Electronic Application of Unbridled Solar, LLC for Certificates of Construction for an approximately 160 Megawatt Merchant Electric Solar Generating Facility and	) ) )	Case No. 2020-00242
Nonregulated Electric Transmission Line in Henderson and Webster Counties, Kentucky	)

# **Response to Siting Board Staff's First Request for Information**

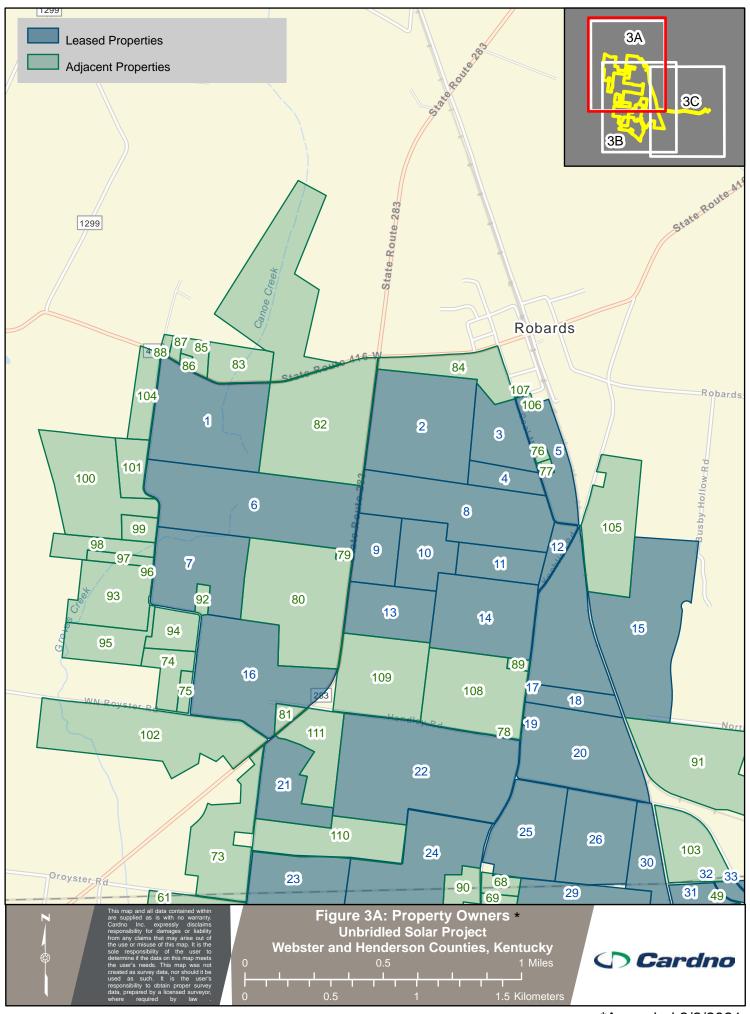
7. Refer to the Application, Exhibit I, page 5, Section 2.2.1. – Facility Compatibility. Identify those property owners who expressed concerns with the viewshed; provide copies of the visual renderings as mentioned in this section; and provide copies of the screening plan agreements referenced in this section.

There are two property owners who expressed concerns with their viewshed during the

public information meeting open hours in August 2020. The owners of neighboring property PID #71-47 (keyed as #85 in Amended Exhibit J, Figure 3A, attached hereto) had raised a viewshed concern, but after reviewing visual renderings of the screening plan from their property, they agreed in writing to the plan. The written approval is subject to redaction requirements and Unbridled requests confidential treatment for this non-party's written communication in the accompanying Petition for Confidential Treatment. The written approval is attached to this response as Figure ESB 07-A- PID #71-47 Written Approval. The visual renderings from this property facing south towards the Project site is attached to this response as Figure ESB 07-B- PID #71-47 Visual Renderings. The owner of neighboring property PID #72-2 (keyed as #92 Amended Exhibit J, Figure 3A, attached hereto) had raised a viewshed concern and has since reviewed visual renderings of the viewshed from their property and a diagram of the screening plan. The landowner is still in discussion with Unbridled representatives regarding the screening plan. A screening plan will be agreed to prior to construction. In the event a screening plan is not agreed to prior to construction, Applicant will default to the Henderson County Zoning Ordinance Section 30.2(d) screening requirement at this property. A copy of the visual renderings from this

property facing east towards the Project site, as well as the screening plan diagram, is attached to this response as Figure ESB 07-C- PID #72-2 Visual Renderings.

Figure 1. Planting Template Plan (not to scale)

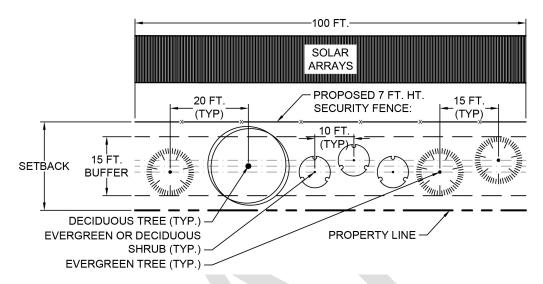
- 20. Refer to the Application, Exhibit K, Sheet Number UNB-L-900-01, Vegetative Screening Concept Plan.
  - a. Under General Notes, Pre-Construction, explain what is meant by "ALL PLANT MATERIALS AND INSTALLATION SHALL COMPLY WITH RECOMMENDATIONS AND REQUIREMENTS OF ANSI Z60.1 'AMERICAN STANDARD FOR NURSERY STOCK'."
  - b. Provide the average height of the typical deciduous tree, evergreen tree, shrub, and multistem tree that will be planted five years after planting, at maturity, and provide when each of the typical deciduous tree, evergreen tree, shrub, and multistem tree will reach maturity.

- a. ANSI Z60.1 is the industry standard for quality in nursery stock. It is published
  by AmericanHort and accredited by American National Standards Institute
  (ANSI). Unbridled will utilize plant materials and installation practices that meet these
  standards.
- b. Please see the following table for the projected growth of each species. Maturity for these species will typically occur by 20 years after planting. Maturity for these species will typically occur by 20 years after planting.

Vegetation Type	Height at Installation	Height at Year 5	Height at Maturity
Evergreen Tree	3 ft	8-11 ft	15-20 ft
Deciduous/Multistem Tree	3 ft	10 ft	25 ft
Evergreen/ Deciduous	2ft	7 ft	10-12 ft
Shrub

AMENDED EXHIBIT J FIGURES

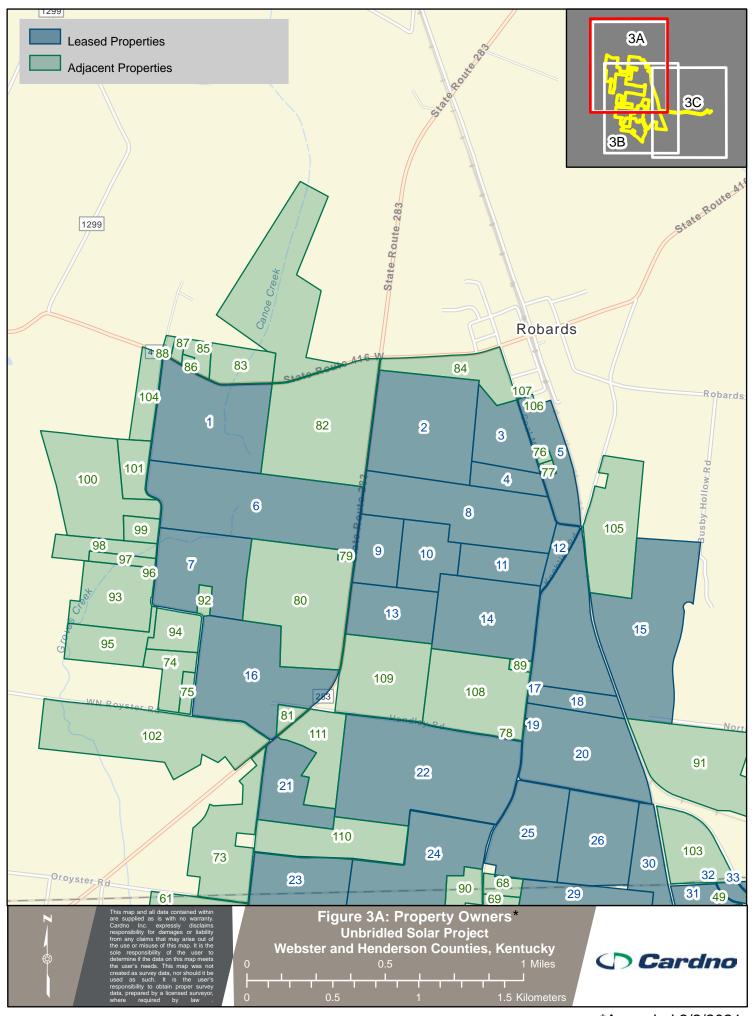
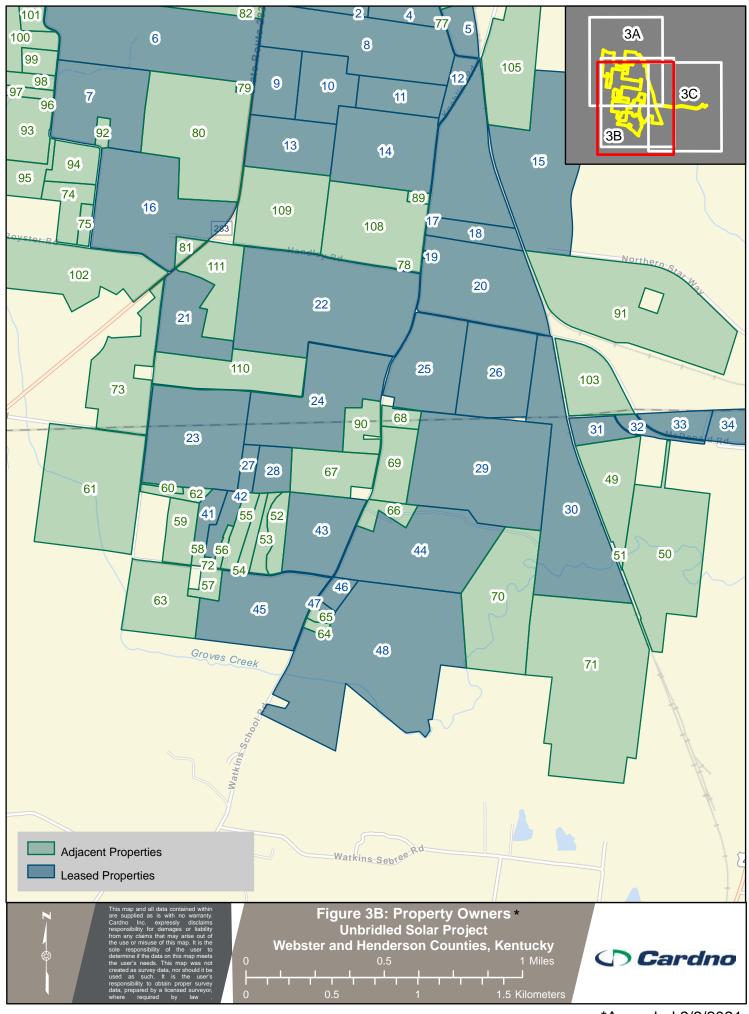
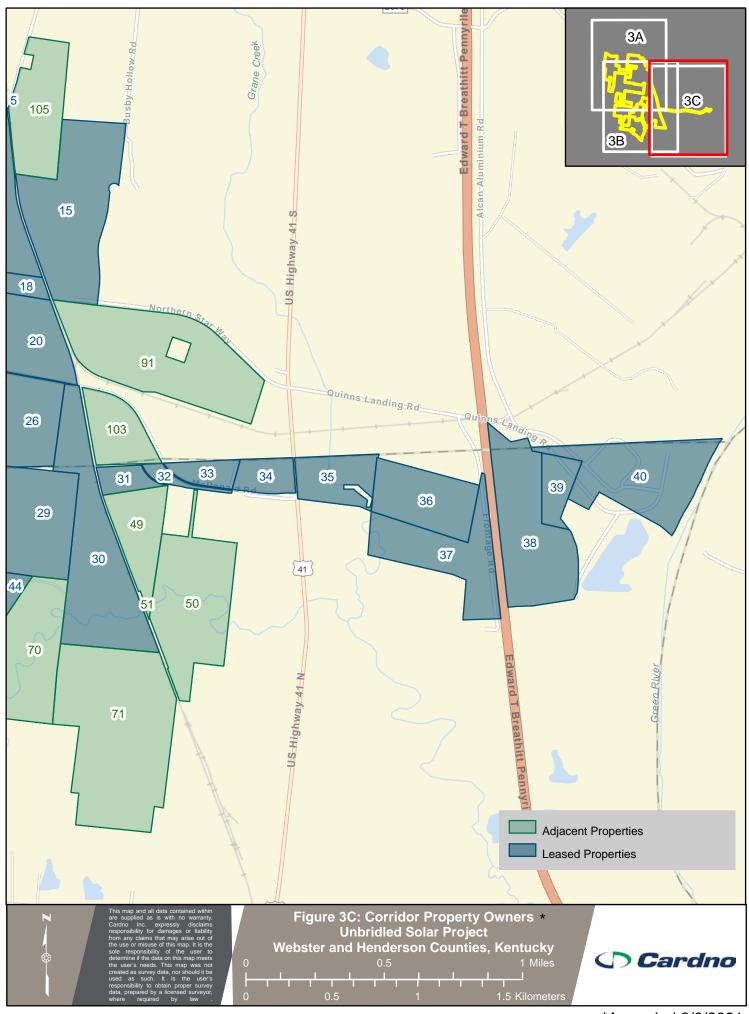
- a. Confirm that the 63 landowners are the only landowners who own property that are adjacent the proposed solar facility site.
  - b. Provide a map and property owner key that identifies all neighboring parcels that is similar to the map and property owner key in Exhibit J, Figure 3: Property Owners and Property Owner Key.

- c. Page 1 of Exhibit D states that the 63 landowners were notified by registered mail on November 10, 2020. Identify which of these landowners along with the Map Reference number and Parcel ID, if any, did not receive the registered mail that was sent on November 10, 2020. Also provide what efforts were subsequently made to notify any landowners that did not receive the November 10, 2020 letter.

- b. A map and property owner key that identifies all neighboring parcels is attached to this response as Amended Exhibit J, Figure 3.
- c. One letter from the November 10, 2020 notice of application mailing was returned to our office. The letter was sent to the owner of parcel #083-005-000 in Webster County. The map reference number is 31 in Amended Exhibit J, Figure 3. Public data had incomplete and inaccurate address information for this parcel, so the letter was not addressed correctly. The parcel is owned by West Kentucky Industrial Development Authority and Unbridled has a transmission line easement for this property. The November 10, 2020 notice of application letter was delivered to the company's mailing address.

Four letters from the November 10, 2020 notice of application mailing are still "in transit" according to USPS. One letter was sent to the owner of parcels #61-65, #71-44, #72-1 in

Henderson County and #077-002-003 in Webster County. The map reference numbers are 6, 7, 24, and 102 in Amended Exhibit J, Figure 3. The landowner is both an adjacent and participating landowner of the Project and Unbridled representatives have been in contact regarding the Project development. A subsequent letter providing notice of application was mailed to this landowner in January 2021.

The second letter still in transit was sent to the owner of parcel #72-14 in Henderson County. The map reference number is 25 in Amended Exhibit J, Figure 3. The landowner is a participating landowner of the Project and Unbridled representatives have been in contact with this landowner about the development of the Project. A subsequent letter providing notice of application was mailed to this landowner in January 2021.

The third letter still in transit was sent to the owner of parcel #71-33 in Henderson County. The map reference number is 77 in Amended Exhibit J, Figure 3. A subsequent letter providing notice of application was mailed to this landowner in January 2021.

The fourth letter still in transit was sent to the owner of parcel #083-003-001 in Webster County. The map reference number is 51 in Amended Exhibit J, Figure 3. A subsequent letter providing notice of application was mailed to this landowner in January 2021.

AMENDED EXHIBIT J FIGURES

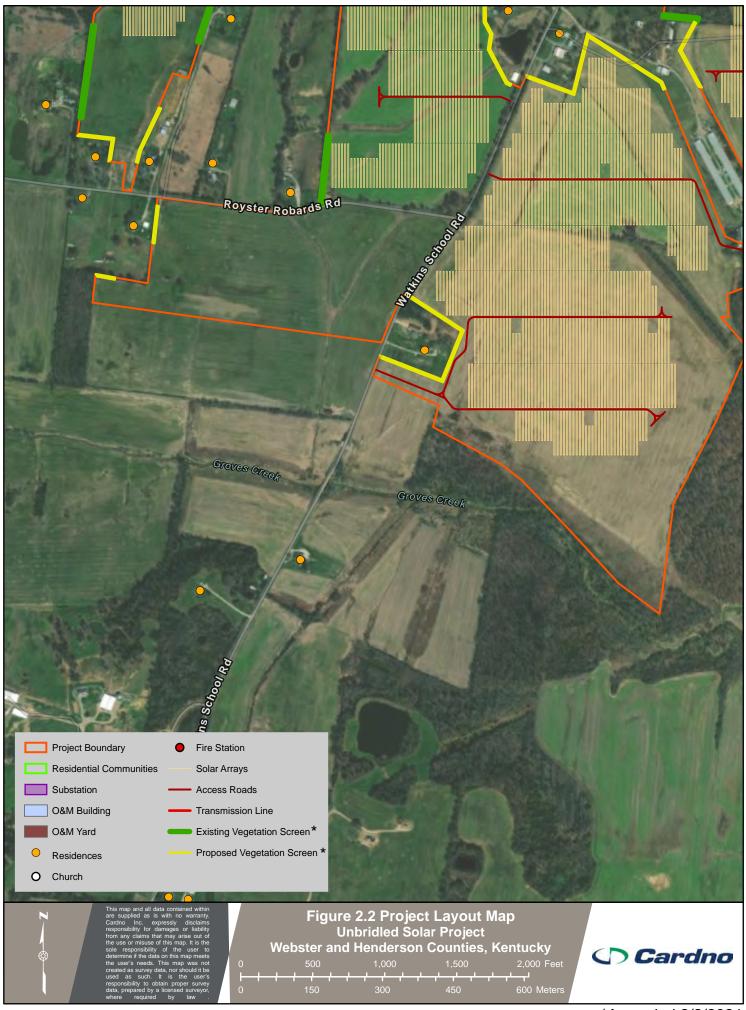
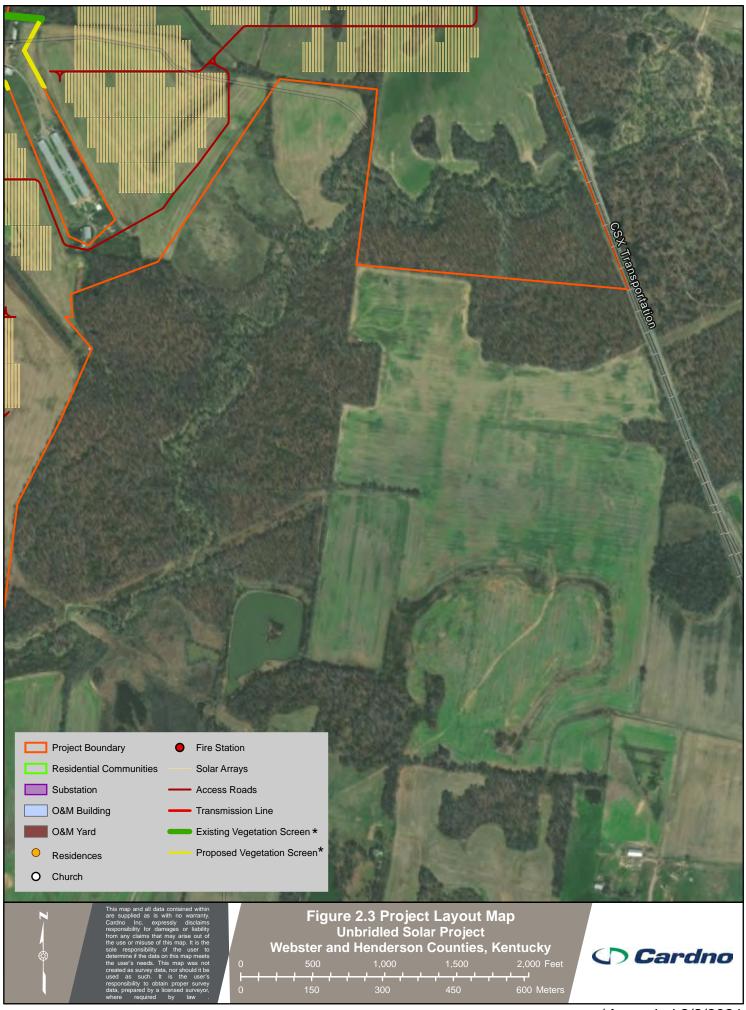
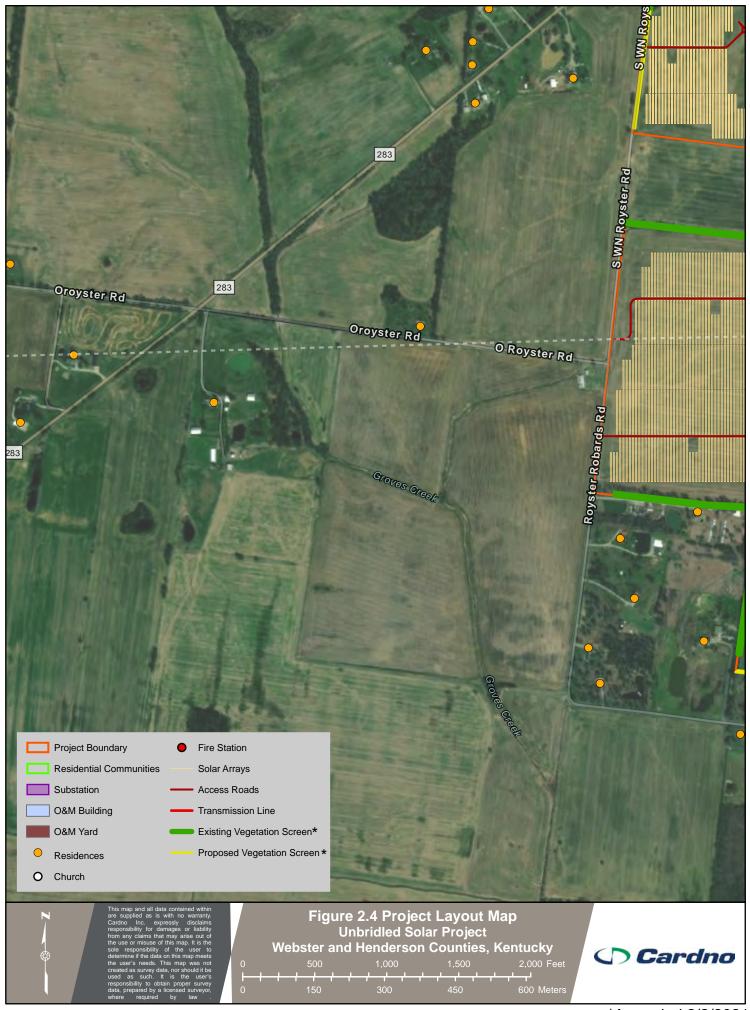
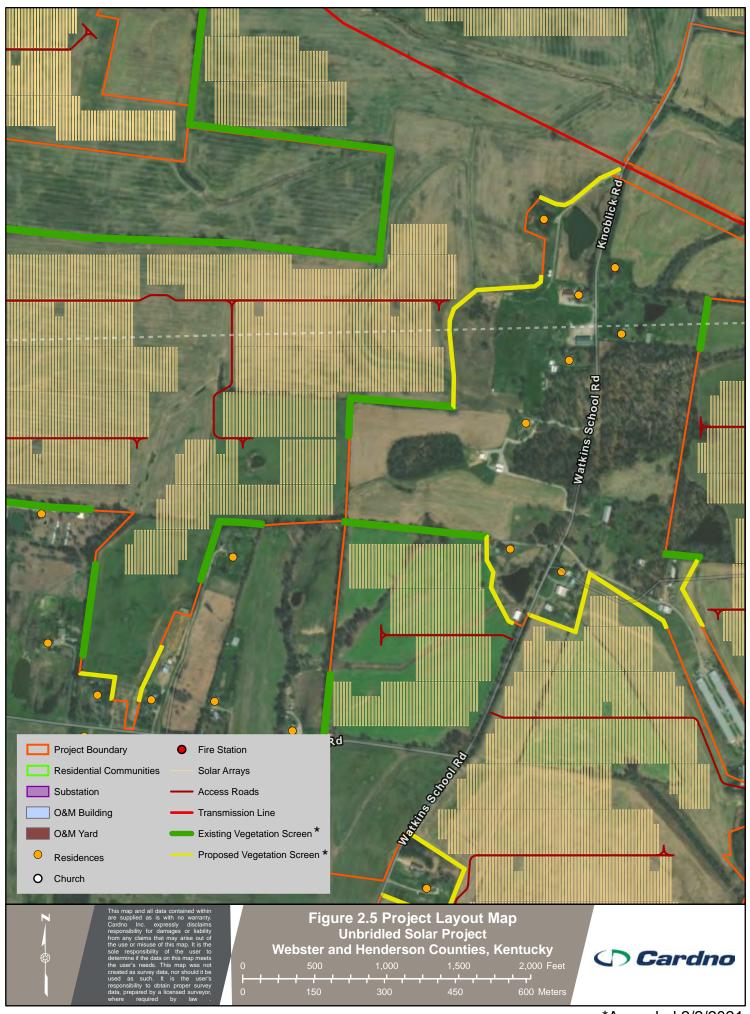
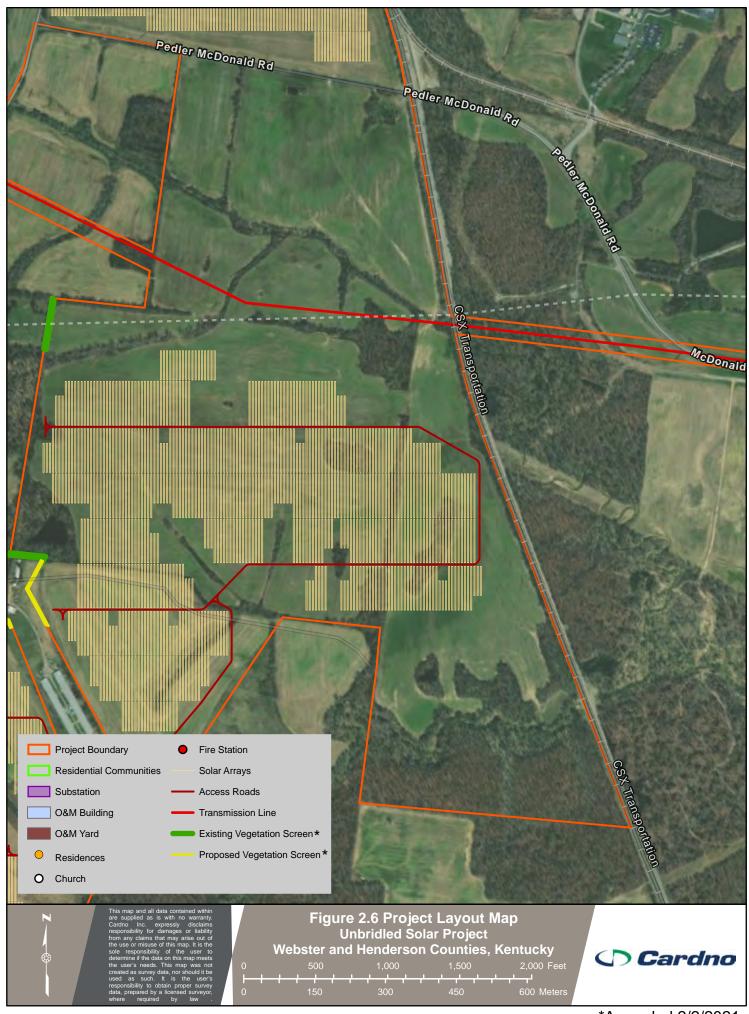
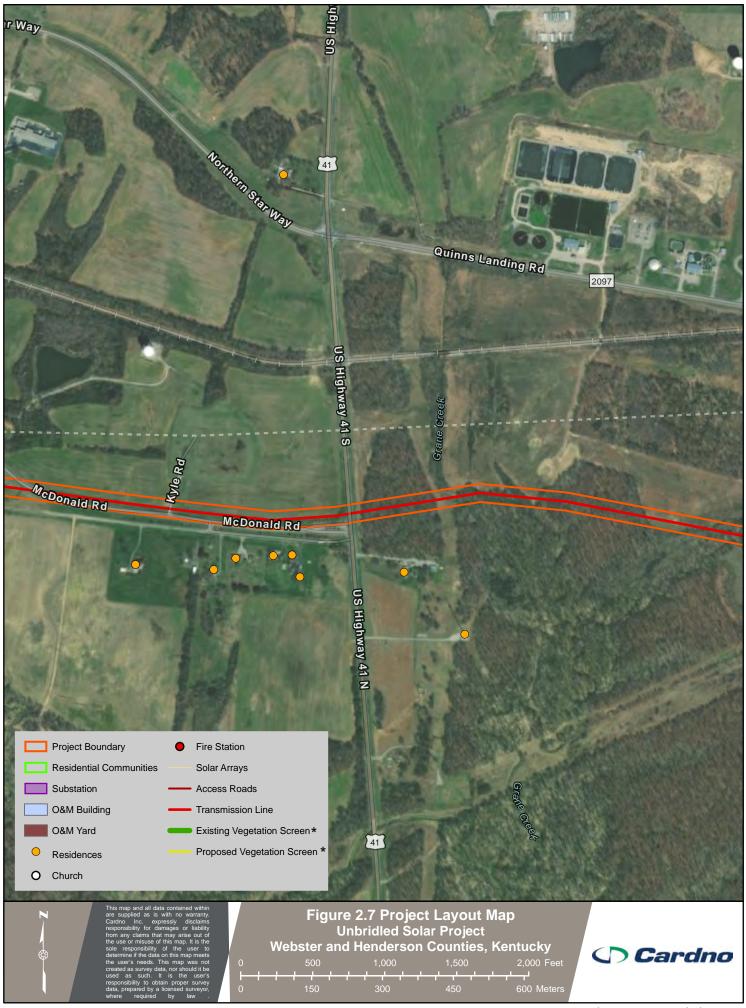
7. Do the "Vegetation Screen(s)" shown in Exhibit J (Application Figures) all indicate new vegetation screening that will be planted by Unbridled Solar, or do they include existing vegetation screens?

The Application figures have been updated in Exhibit J to accurately show both existing vegetation screens and proposed new vegetation screens. See Amended Exhibit J, Figures 2.2-2.17 attached to this response. See also Amended Exhibit K, Sheets UNB-T-100-01, UNB-E-500-03, UNB-E-502-01, UNB-E-502-02, UNB-E-502-03, attached to ESB 02 Response.
